Addendum #2

Bid Opportunity: 23-7362-RFT

**Waterloo-Oxford District Secondary School –
Family Studies Renovation & HVAC Upgrades**

A2.1R

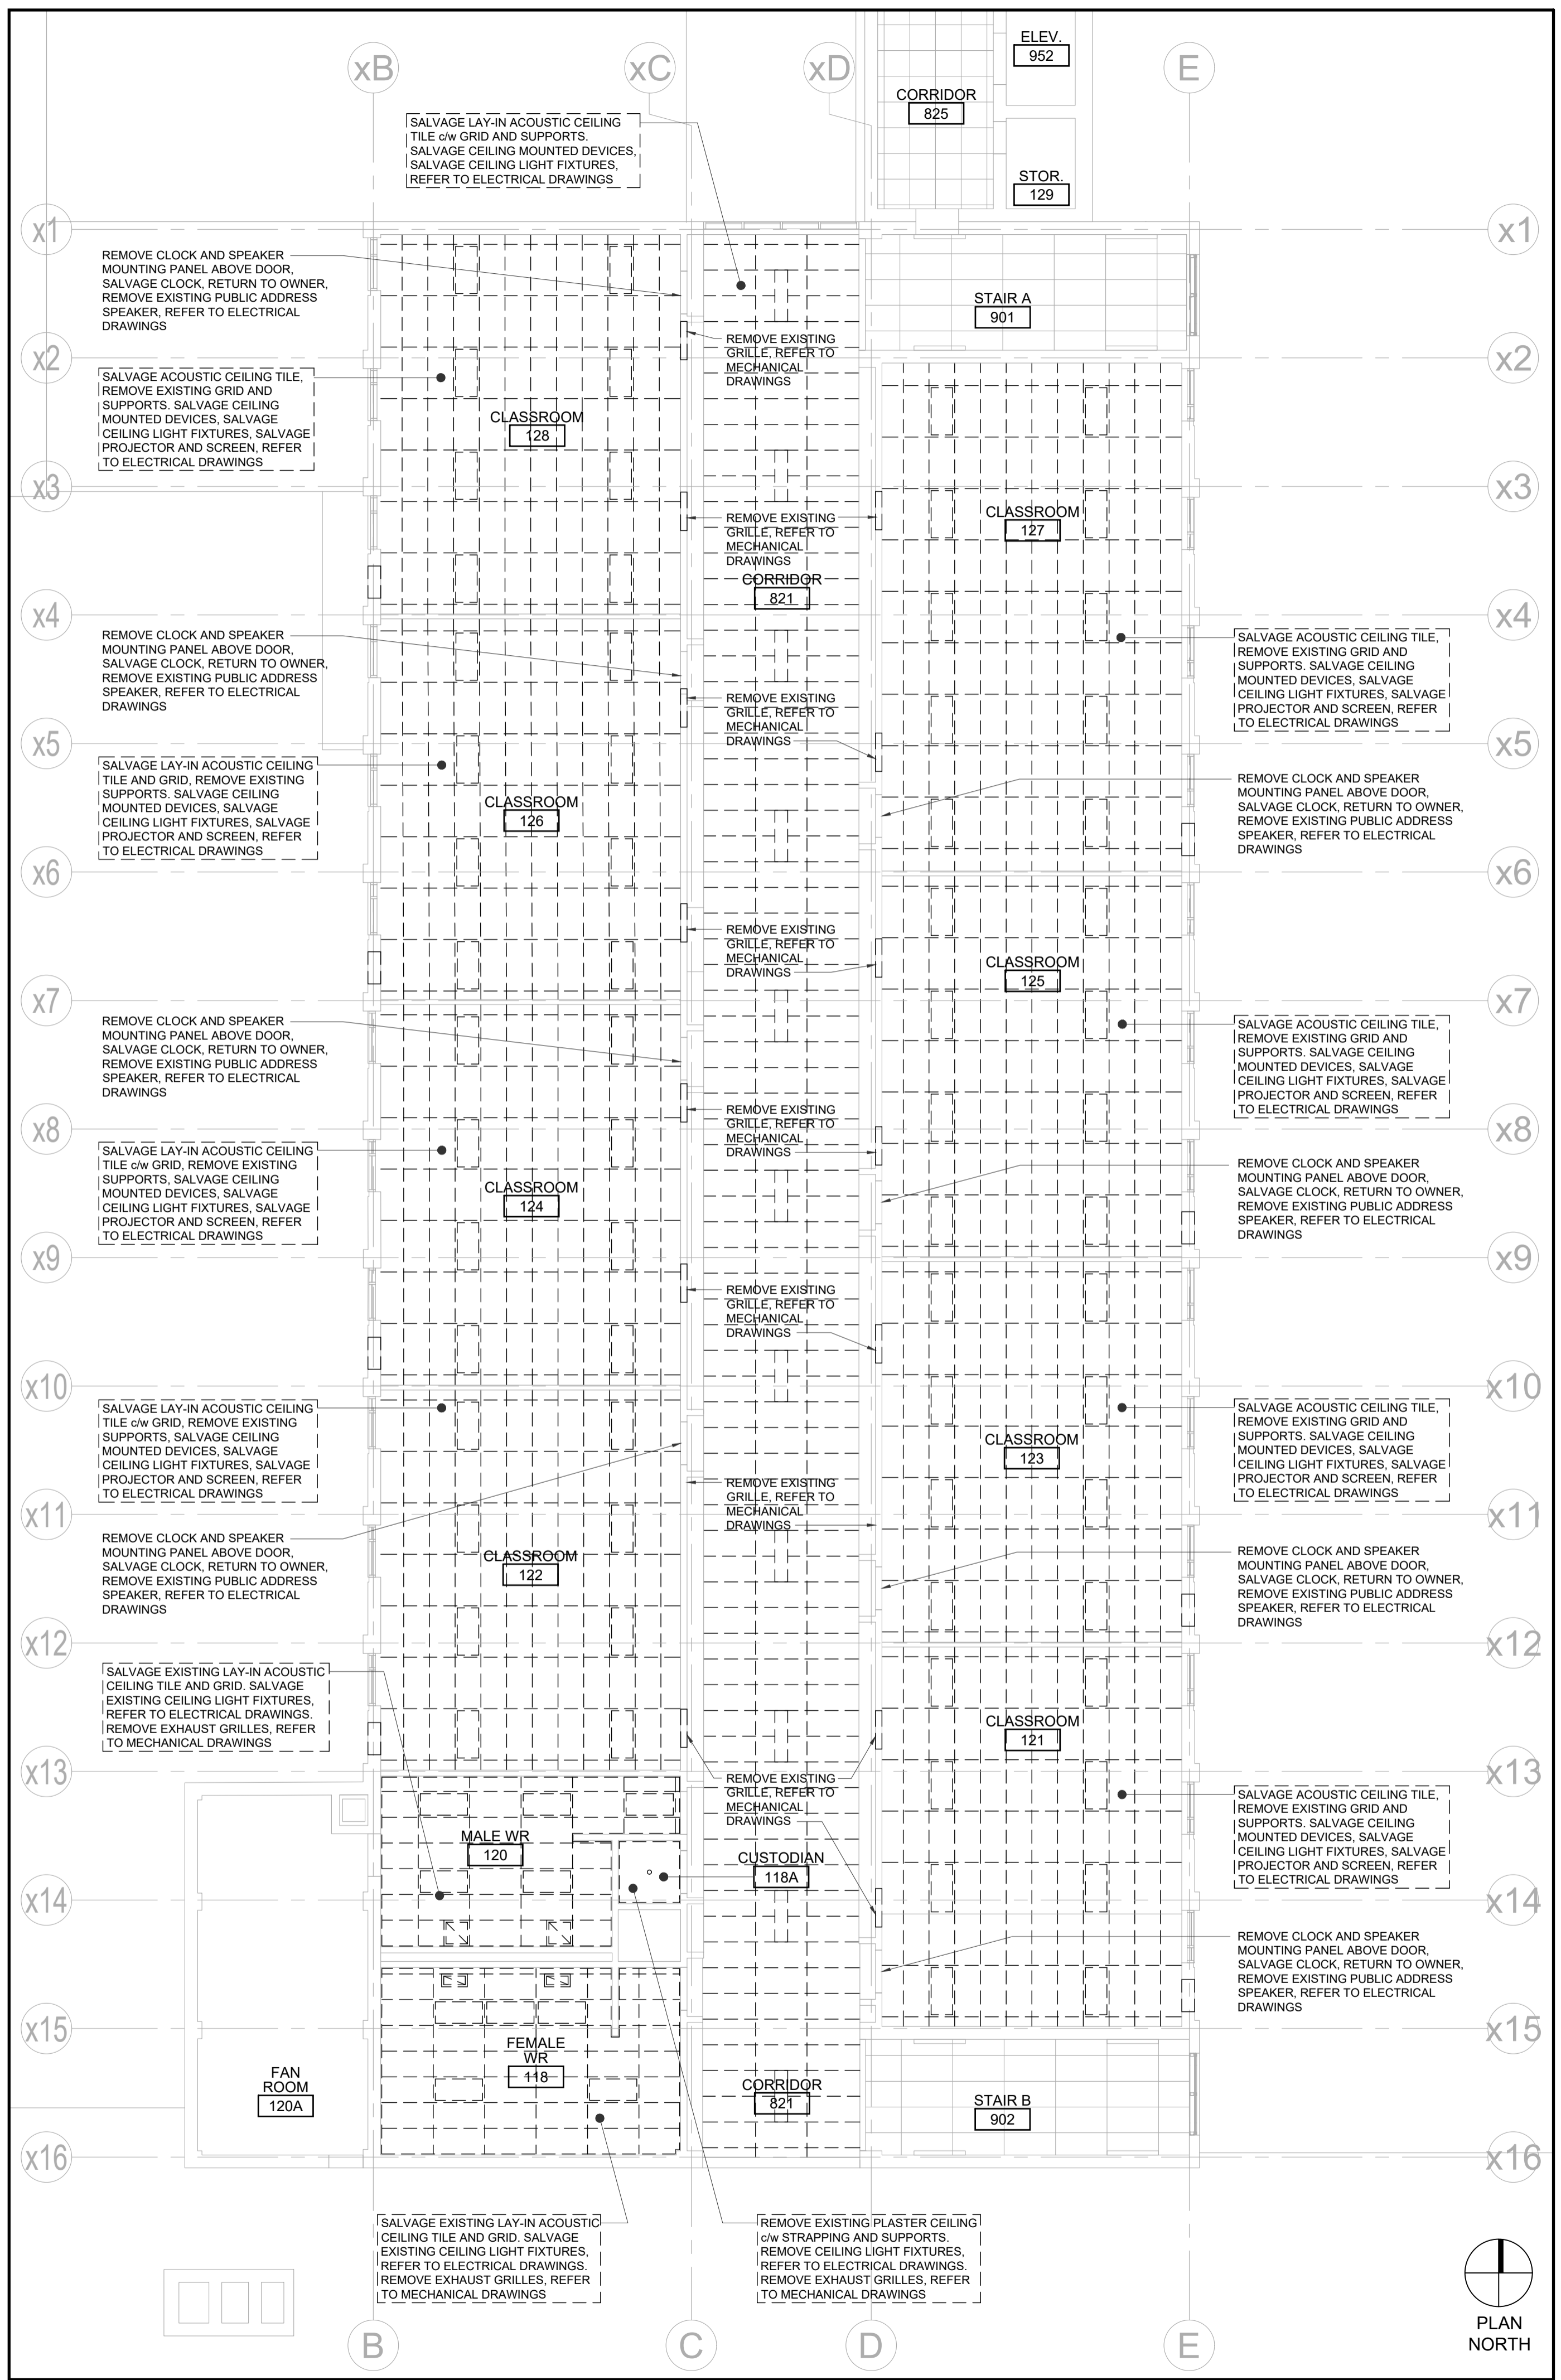
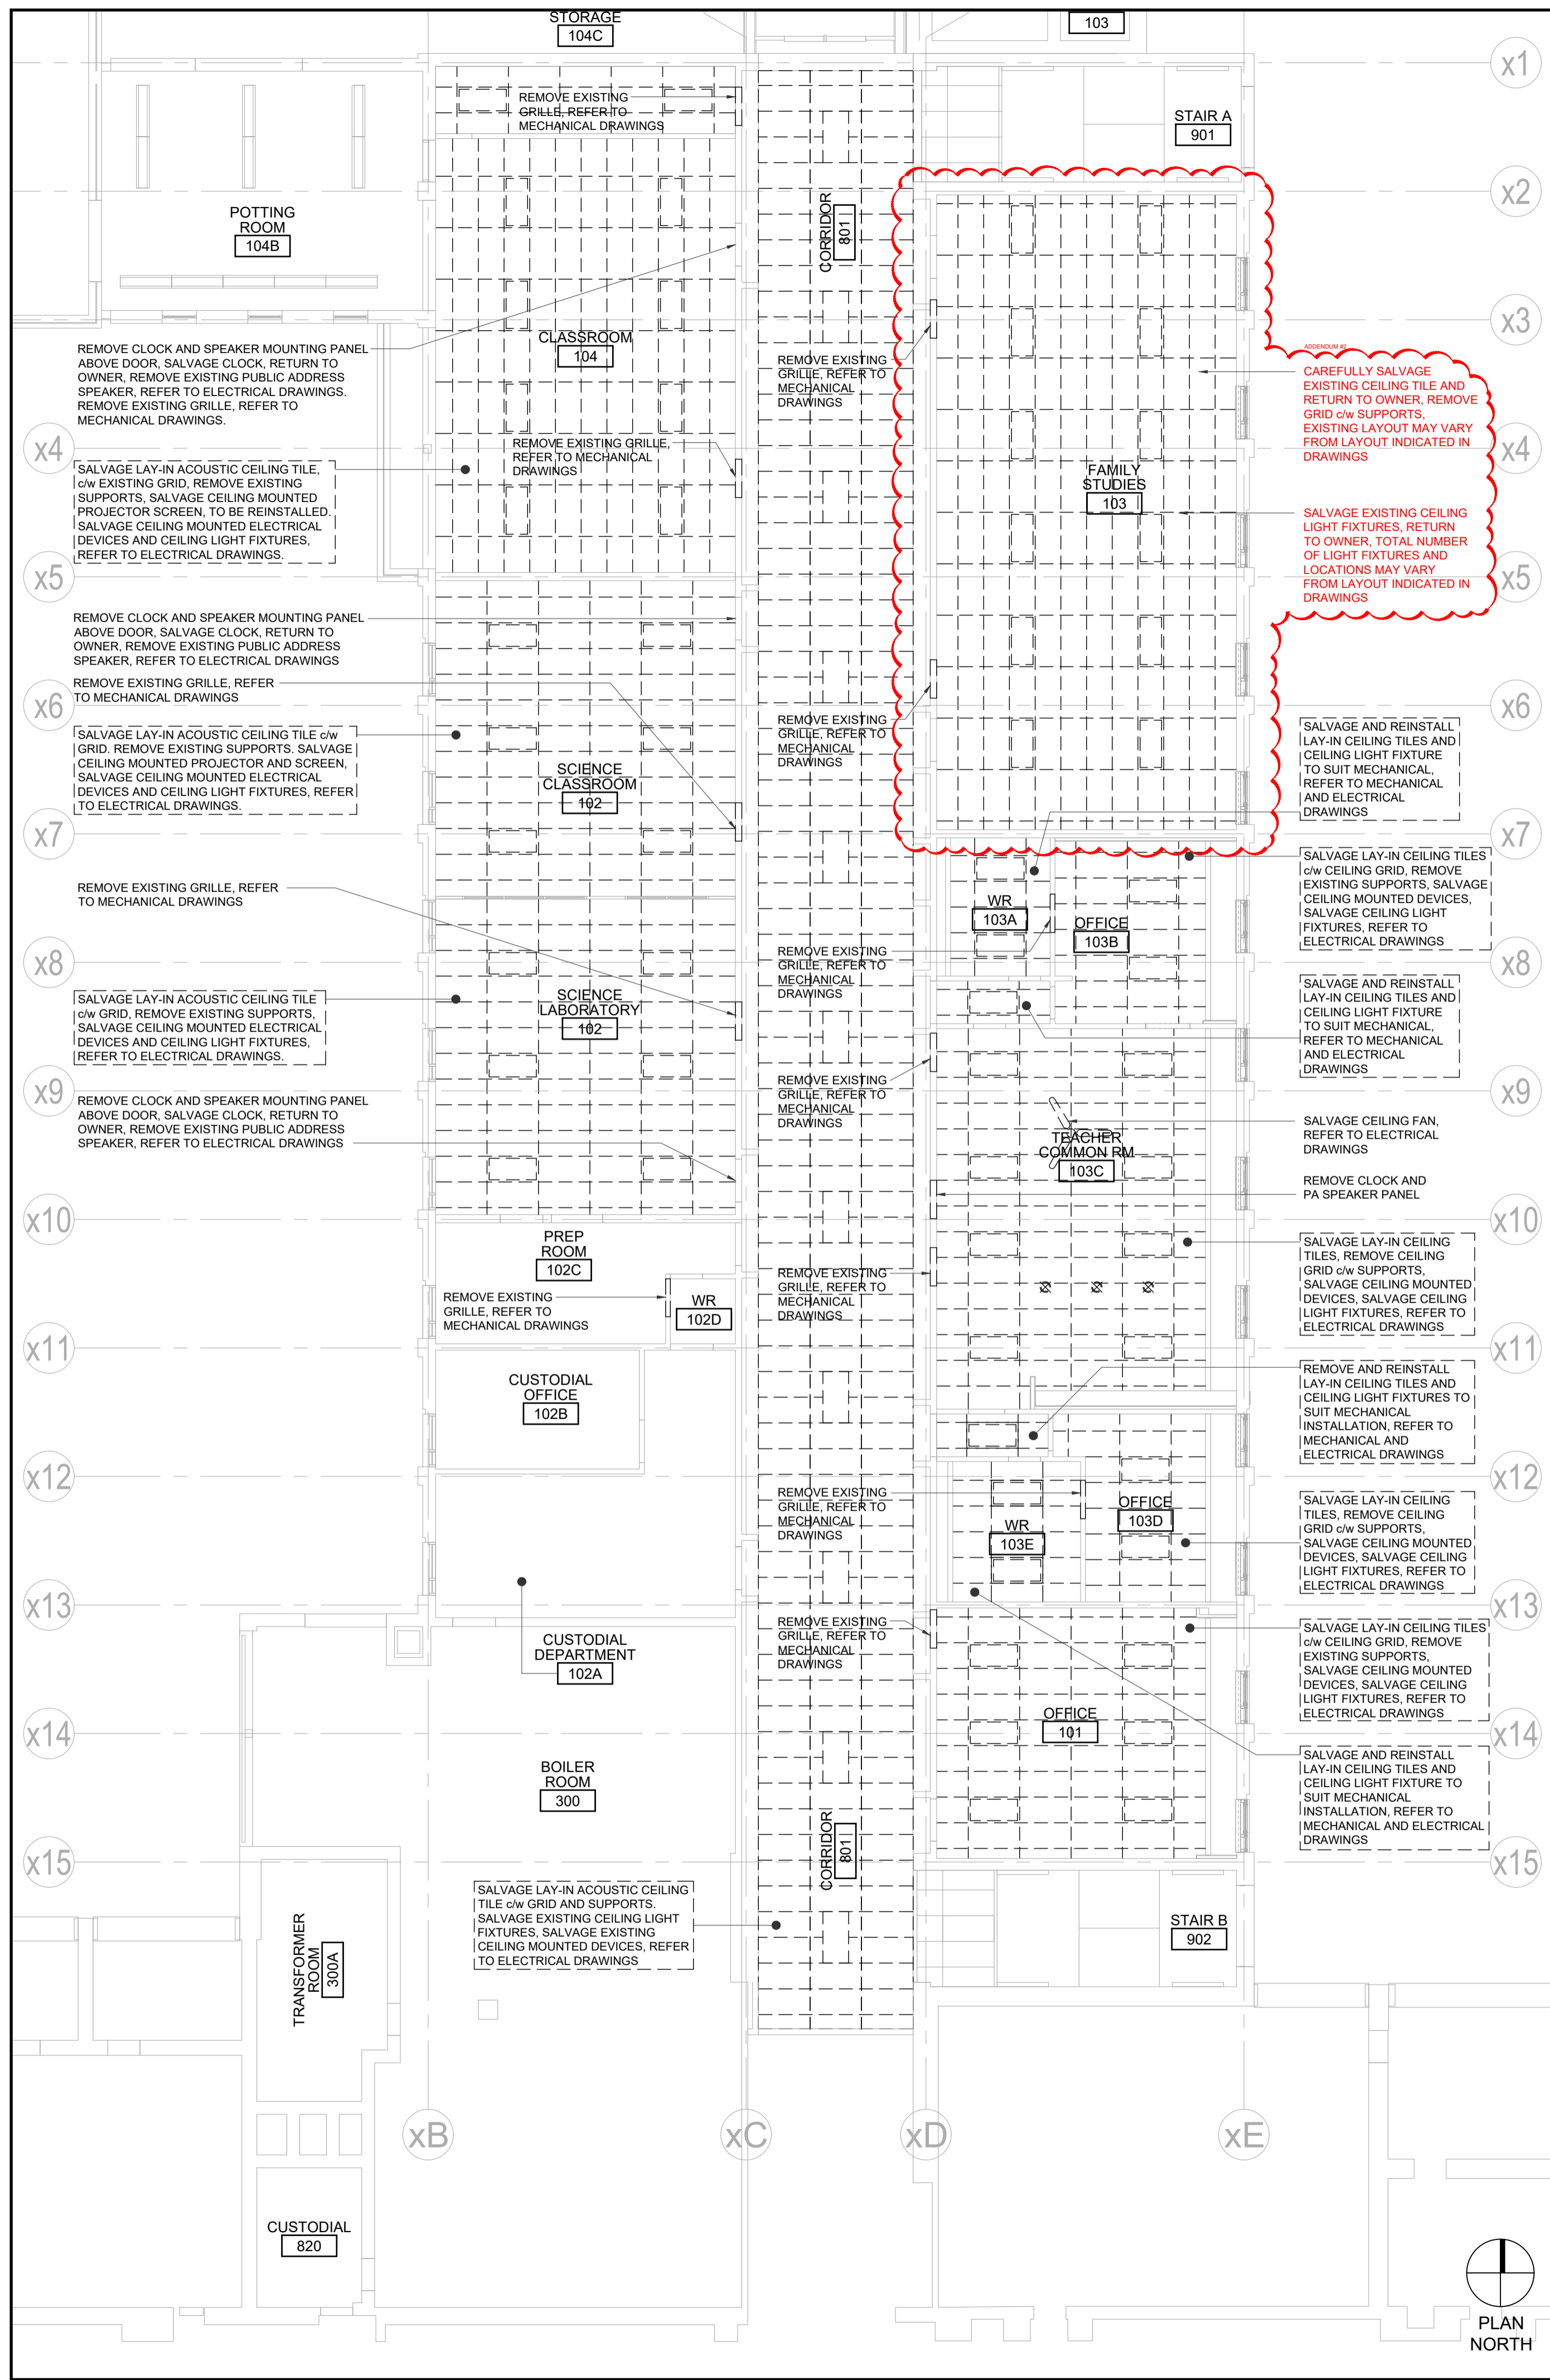
4. Drawing A2.1 Partial Demolition Floor Plans
 1. **REPLACE DRAWING A2.1 WITH DRAWING A2.1R, ATTACHED. DETAIL REFERENCES HAVE BEEN ADDED/ REVISED.**
5. Drawing A2.3 Partial Reflected Ceiling Demolition Plans
 1. **REPLACE DRAWING A2.3 WITH DRAWING A2.3R, ATTACHED. SCOPE OF WORK IN FAMILY STUDIES 103 HAS BEEN REVISED.**
6. Drawing A3.1 Partial Floor Plans
 1. **REPLACE DRAWING A3.1 WITH DRAWING A3.1R, ATTACHED. DETAIL REFERENCES HAVE BEEN ADDED/ REVISED.**
